SI B51 06 13  
Body Equipment

March 2013  
Technical Service

**Driver's Door Mirror Adjustment Range Not Sufficient**

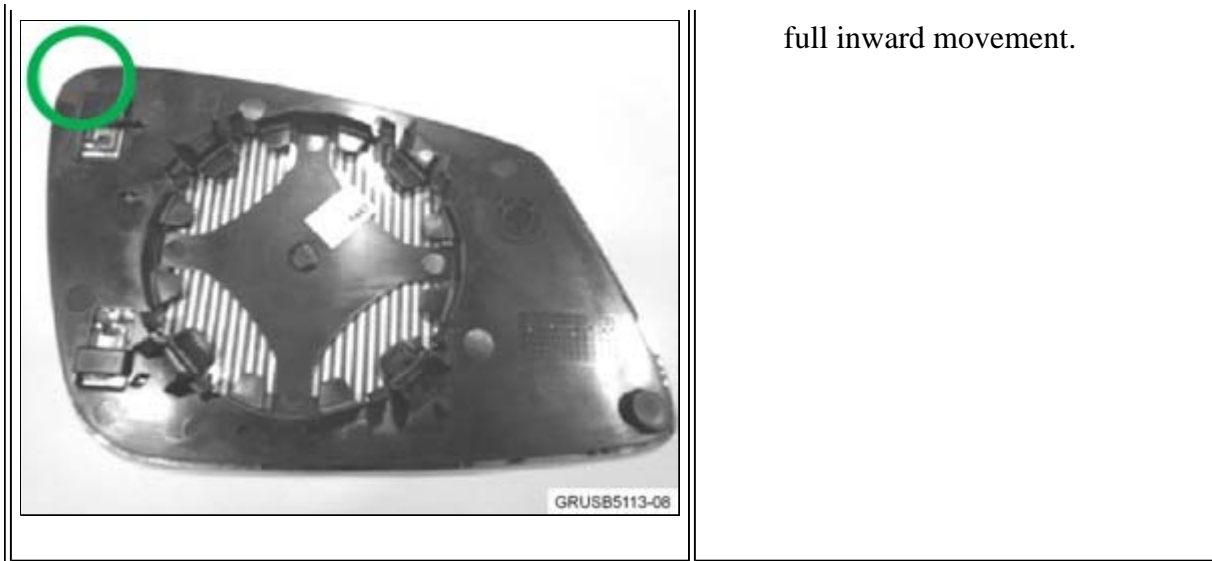
The driver's door mirror inward travel is not sufficient.

The mirror glass carrier inward bump stop is too high and limits the inward travel.

1. Place the removed mirror glass on a clean work surface. Locate the upper/inner plastic bump stop (red circle).

2. Use an appropriate grinding tool or sander to fully remove the plastic bump stop (green circle). Use caution when removing the bump stop to prevent damage to the mirror glass and the mounting lugs. Reinstall the modified mirror and check for

full inward movement.
